# RICHMOND FERRY TO BRIDGE TO GREENWAY COMPLETE STREETS PLAN

## APPENDICES

# Appendix A

## Public Comments on Draft Plan

Public Comment #1 - Figure Referenced

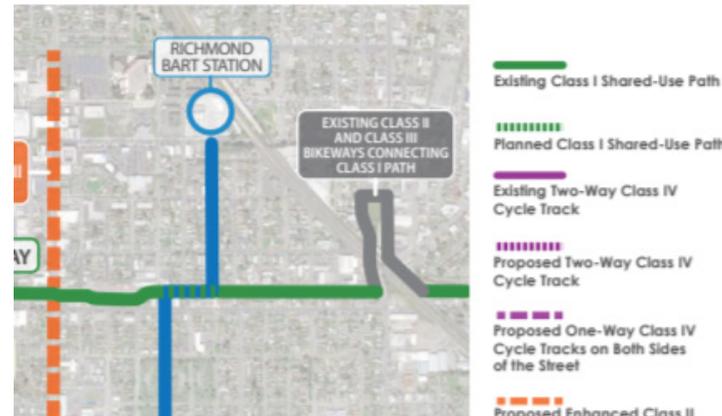
- Pg 5-20 – The intersection of Tewksbury and Castro is rather dangerous and it would be great to see more detailed long-term improvements proposed. Vehicles entering from the north are unrestricted and can enter during all phases of the adjacent traffic signal, which includes cars coming off of the freeway. When we built the cycle track and protected intersection, there was even talk of having this intersection connected to the adjacent signal. I would love to see a blurb about signalization, coordination with Caltrans, or such. Also, I don't think "the existing protected intersection at Castro

Street is unsightly and awkward." The current installation is very similar to things proposed all over this plan!
